DEPARTMENT OF THE ARMY
NEW ORLEANS DISTRICT, CORPS OF ENGINEERS
P.O. BOX 60267
NEW ORLEANS, LOUISIANA 70160-0267

SUBJECT: Independent External Peer Review of Greater New Orleans Hurricane and Storm Damage Risk Reduction System (GNOHSDRRS): Design Elevation Report and Addendum

**Final Panel BackChecks on
USACE Evaluation Responses
on the
HSDRRS Design Elevation Report
Review 1**

NATURAL, LONG-TERM, RELATIVE SUBSIDENCE RATES DERIVED FROM RADIOCARBON DATING OF BURIED PEAT DEPOSITS, US ARMY CORPS OF ENGINEERS, NEW ORLEANS DISTRICT

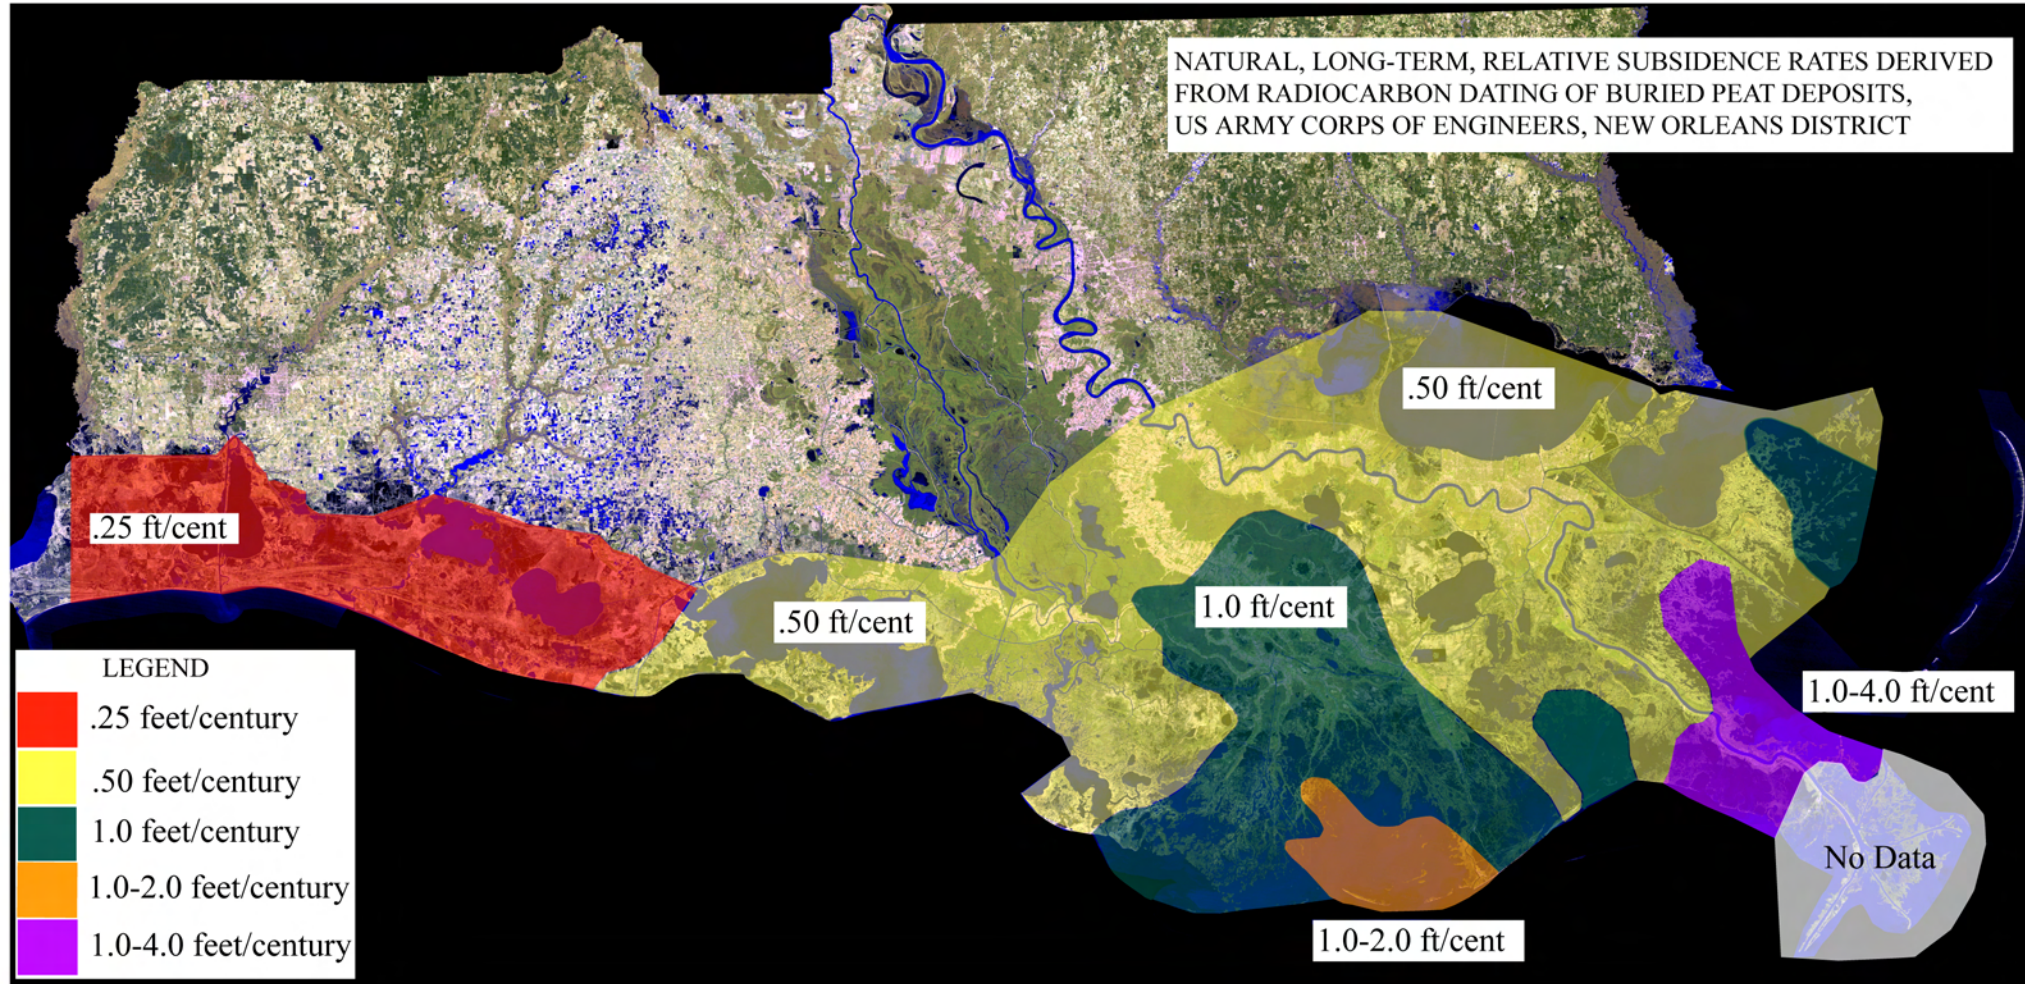
Final Panel Comment 2:
Additional documentation regarding the relative sea level rise (RSLR) assumption of 1 foot in 50 years that was used to establish future surge and wave characteristics is needed in the HSDRRS Design Elevation Report to justify what appears to be a value on the low end of predicted RSLR ranges.
Basis for Comment:
<p>The HSDRRS Design Elevation Report makes it apparent that relative sea level rise (RSLR) is an important, but uncertain, variable for estimating future surge and wave overtopping rates used in the HSDRRS design. The HSDRRS Design Elevation Report uses a RSLR of 1 foot in 50 years based on USACE (2004; as cited on HSDRRS Design Elevation Report page 57). The Panel understands that the RSLR range estimated for the Louisiana Coastal Area Ecosystem Restoration Projects Study Area ranged from a low of 1.5 feet/50 years to a high of 3.2 feet/50 years with an intermediate rate of 1.9 feet/50years based on local historic subsidence rates plus estimated eustatic sea level rise. The National Research Council (NRC) has reportedly estimated an intermediate RSLR of 1.6 ft in 50 years.</p> <p>The HSDRRS Design Elevation Report says that the RSLR will be revisited and updated as part of the expected 10-year reviews. However, it may not be cost-effective or even practicable to delay dealing with RSLR that proves to be significantly greater than the 1-ft per 50 yrs presently assumed in the HSDRRS Design Elevation Report. Therefore, because there is so much uncertainty in future RSLR, and 1 foot in 50 years appears to be toward the lower end of the potential range, the HSDRRS Design Elevation Report needs a more thorough discussion of the justification for adopting a RSLR of 1 foot in 50 years and explaining how the HSDRRS would be retrofitted if RSLR proves to be significantly greater than presently assumed.</p> <p>The Panel also notes that the subsidence discussion at HSDRRS Design Elevation Report page 11 is not clear regarding long-term levee soil-consolidation settlement due directly to levee construction. This levee-caused settlement is distinct from regional or local long-term subsidence in the absence of levee construction.</p>

Significance – Medium:
RSLR directly affects the future (year 2057) surge elevations and wave characteristics used in the HSDRRS Design Elevation Report, and, therefore, the actual level of protection that will be achieved by the HSDRRS.
Recommendation(s) for Resolution:
<ol style="list-style-type: none">1. Provide a more thorough discussion of the justification for adopting a RSLR of 1 foot in 50 years.2. Explain the implications for HSDRRS performance if RSLR proves to be significantly greater than presently assumed.3. Explain how the HSDRRS would be retrofitted if RSLR proves to be significantly greater than presently assumed.
USACE Final Evaluator Response (#2):
Concurred. See attached file comment2response.pdf for response.
Final BackCheck Response (#2):

See attached figure [Subsidencerates.jpg](#)

The predicted sea level rise (or eustatic sea level rise), 1.3 ft per century, was taken from the Intergovernmental Panel on Climate Change Third Assessment Report, published in 2001. (Note - Fourth Assessment Report had not been published at the time of analysis; it was published later in 2007)

Compare and contrast this with the methodology performed for HSDRRS using the rate of 1 ft in 50 years. 1 ft natural subsidence was placed in ADCIRC model and a subset of storms modeled. Water level change values were developed from the model results. The water level change values were added to the 1% exceedence water level. Adjustments were made to wave characteristics. Then the height of the levee was determined using HSDRRS design guidelines.

To show the difference in design elevations with the 2 methods, the LACPR levee elevation for St Bernard levees for future conditions using the mid range value would be 28.1 to 30.6 ft. Using the HSDRRS methodology, the future condition elevations are 29.0 to 31.5 ft, about 1 ft higher.

A USACE Circular was published in June 2009 prescribing the use of gage data to determine the relative sea level change, a different process than what was followed for LCA. As a result of the circular, an assessment was made regarding the design elevations in context with the three different rates of sea level change prescribed in the EC. The assessment included a description of how the HSDRRS can be modified in the event the actual change in the design water levels is greater than the predicted change.

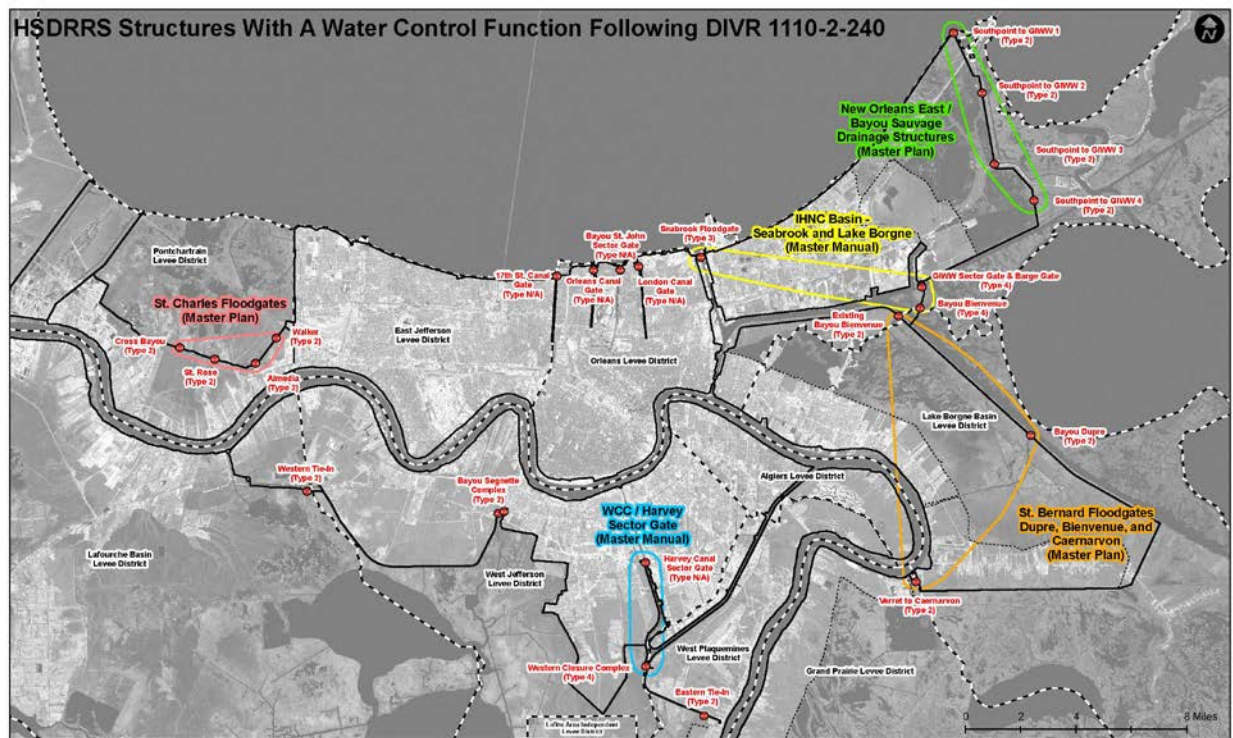
Final Panel Comment 3:
The DER and Addendum do not specifically address how the various HSDRRS components work as an effective system.
Basis for Comment:
<p>The DER Addendum discusses the various project features, elements, and components that are intended to work effectively as a system, which is a major design intent and expectation of the HSDRRS. The DER Addendum does not, however, discuss how these components work effectively as a system that is a critical subsystem of the HSDRRS. Such a discussion, at a conceptual level of detail, would improve the technical quality of the DER Addendum.</p> <p>Furthermore, the DER Addendum also does not discuss the organizational and operational details associated with system performance (e.g., identifying administrative triggering action events or dates, chains and lines of intra- and extra-USACE communications and notifications, decision-making requirements and authority, oversight). Such details may be important enough to warrant discussion, perhaps as a separate appendix to the DER Addendum.</p>

<p><i>USACE please elaborate on the reason for your Concur or Non-Concur statement here: The DER is a hydraulic document; the organizational and operational details associated with system performance are addressed in the System Management Plan, a document presently being prepared. The System Management Plan discusses the long term management of the HSDRRS system, including features such as Southeast Louisiana and storm proofing. Another set of documents that address system performance are the water control documents. USACE is required to prepare water control documents for water resource projects as per</i></p>

The DER addendum will be revised to mention that there is a System Management Plan that addresses the organizational and operational details associated with system performance and Water Control documents that also provide detailed organizational and operational details associated with the water control structures. Included in the revised language will be specifics on the Master Water Control Plan for systems such as the IHNC corridor, St Bernard, St Charles, New Orleans East, and Harvey-Algiers, areas with multiple structures that operate together.

You can see these systems on the figure below.

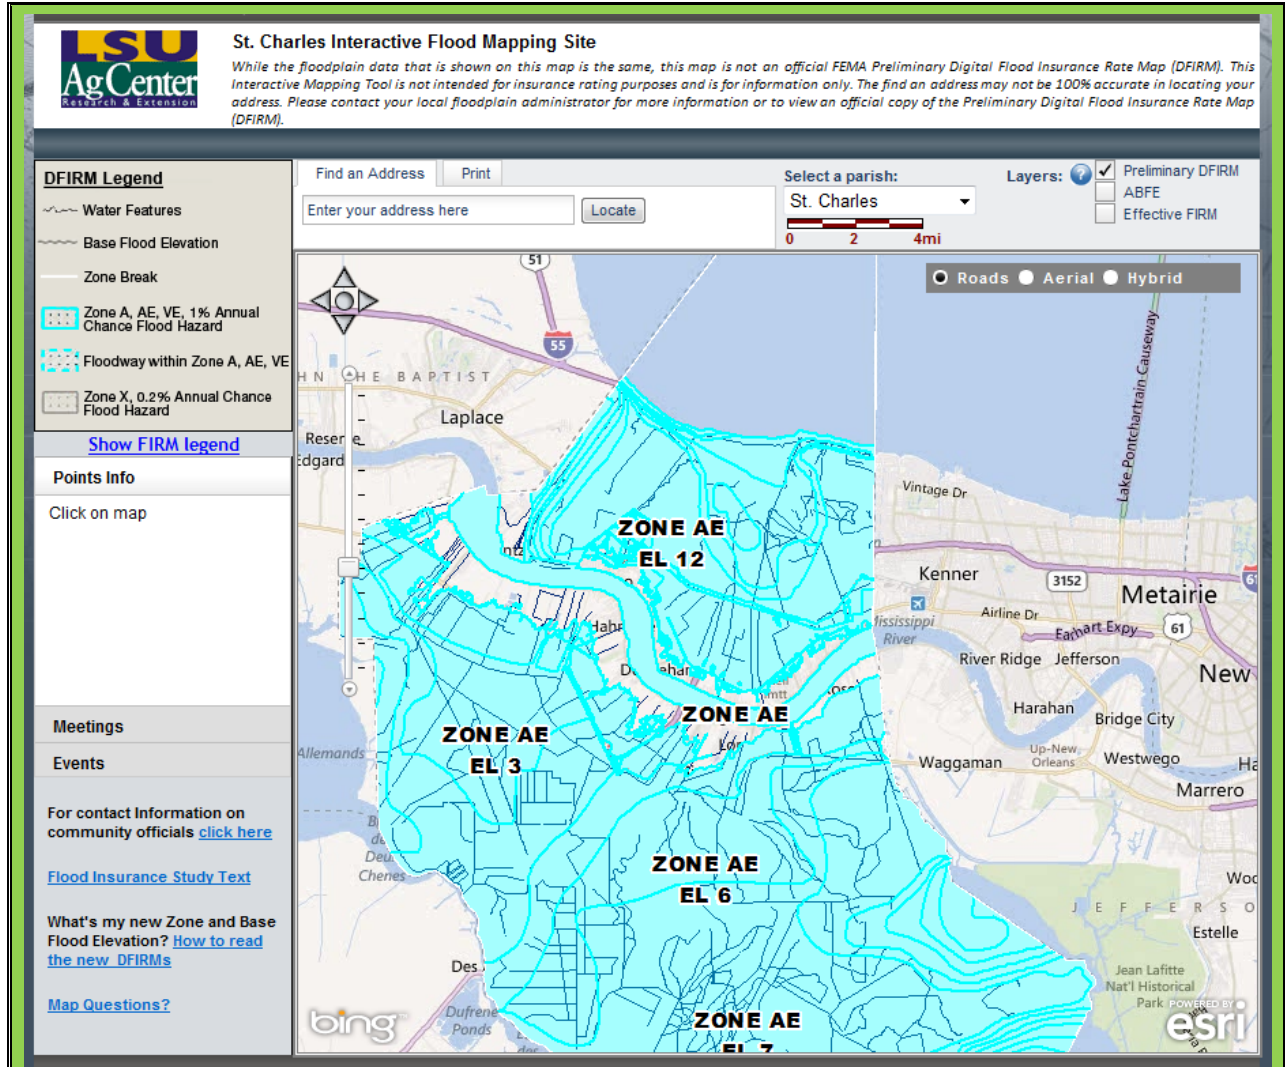
Final Panel Comment 4:
The model analysis for surge levels does not include an update on quantification of the differences with the Federal Emergency Management Agency (FEMA) flood insurance study for the 100-year return period.
Basis for Comment:
<p>The primary purpose of Appendix H “Investigation of ADCIRC Surge Results in St. Charles Parish; May 16, 2008” was to outline the evaluation process of the original ADCIRC model, implement the modified regional geometry and land cover characteristics into the hydraulic model, recompute the peak surge elevations after incorporating the modified regional characteristics into the ADCIRC model, and compare with the FEMA study results in the region of interest (St. Charles Parish).</p> <p>Appendix H adequately describes the relative modifications of the model setup (Model Resolution - refined mesh) and some of the model input parameters (bathymetry and Manning’s roughness coefficient to account for land cover). Physically pertinent alterations were made to the recent FEMA analysis production grid in St. Charles Parish. USACE selected 34 storms from the original 152 Southeastern Louisiana FEMA storm suite as reflective of the most significant storms affecting the St. Charles region for implementation of the updated model and to verify the surge levels reported in the region for the recent FEMA flood insurance study. In general, surge values were lowered between 0.25 and 1.50 feet throughout the region.</p> <p>The comparison of surge results from the updated ADCIRC model in St. Charles Parish with the errors of the 2007 FEMA runs was adequate. However, analysis is required for St. Charles Parish to quantify differences in the 100-year return period from the values previously reported in the recent FEMA flood insurance study was not completed as part of this project. Instead, this analysis was deferred to the USACE New Orleans District Office to complete the study.</p>

Significance – Low:
The modeling analysis process with the revised/updated geologic and hydraulic input parameters is adequate for the region of interest but is incomplete.
Recommendation(s) for Resolution:
<ol style="list-style-type: none">1. Complete the model analysis in St. Charles Parish and compare the results with the recent FEMA flood insurance study for the 100-year return period.
<p><i>USACE Draft Evaluator Response FPC#4: The model analysis for surge levels does not include an update on quantification of the differences with the Federal Emergency Management Agency (FEMA) flood insurance study for the 100-year return period.</i></p> <p><i>USACE PDT please provide a single Concur or Non-Concur statement in regards to the overall Final Panel Comment here: Concur</i></p> <p><i>USACE please elaborate on the reason for your Concur or Non-Concur statement here:</i></p> <p><i>The DER does not include specifics on the FEMA flood insurance studies for the HSDRRS area. The modeling described in Appendix H has been furnished to FEMA who can incorporate the results into the flood insurance study effort; the DFIRM maps were developed in 2008 and presently have changes pending. The following figure shows the preliminary DFIRM, indicating the zone elevation is 12.</i></p>

The table below shows the difference in the 100-year return period surge for the area, as represented by three levee reaches.

As you can see from the table, the difference is less than 0.5 ft in the modeling. The DER will be revised to include language on the comparison of the original hydraulic boundary conditions and the revised hydraulic boundary conditions.
